DART SERVICE INSTRUCTION

TO AMEND INSTALLATION INSTRUCTIONS IIN-D206-570 REV. C & INSTALLATION DRAWING D206-570 REV. D REF. TCCA STC: SH90-19 REF. FAA STC: SH810NE

Α	NEWIS	ISSUE			07.12.12	
REV.		DESCRIPTION		BY	DATE	
DESIGN		DS	DART AEROSPA		ACE LTD	
DRAWN		45	HAWKESBURY, ONTARIO, CANADA			
CHECKE	D	SW	DRAWING NO.		REV. A	
MFG. AP	PR.	Ņ/Ą	DSI 9399	5	SHEET 1 OF 2	
APPROV	/ED	Nat	TITLE		SCALE	
DE APP	₹.		HEATER MODIFICATION KI	Т	NTS	
DATE 07.12.12			COPYRIGHT © 2007 BY DART AEROSPACE LTD THIS DOCUMENT IS PRIVATE AND COMPIDENTIAL AND IS SUPPLIED ON THE EXPRESS CONDITION THAT IT IS NOT TO BE USED FOR ANY PURPOSE OR COPIED OR COMMUNICATED TO ANY OTHER PERSON WITHOUT WRITTEN PERMISSION FROM DART AEROSPACE LTD.

FIGURE 1. TEE FITTING RELOCATION

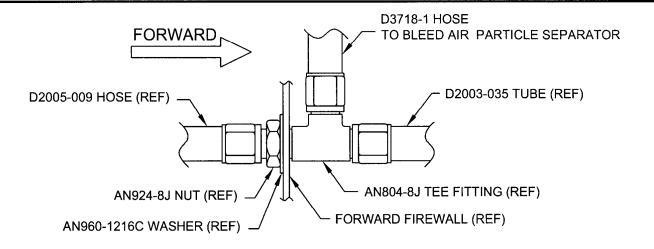
- 1. The existing AN804-8J tee fitting can be moved to the forward side of the forward firewall as shown in Figure 1.
- 2. The D3718-1 hose can be installed off the AN804-8J tee fitting and connected to the bleed air particle separator as shown in Figure 1.

FIGURE 2. D206-570-049 VALVE ASSEMBLY (VIEW LOOKING INBOARD AT RH SIDE)

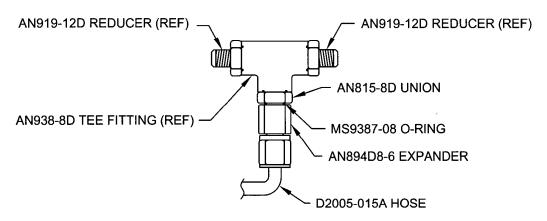
- 5. The AN815-8D union, MS9387-08 O-ring and AN894D8-6 expander can be installed between the existing AN938-8D tee fitting on the RH side of the D206-570-049 valve assembly and the new D2005-015A hose as shown in Figure 2.
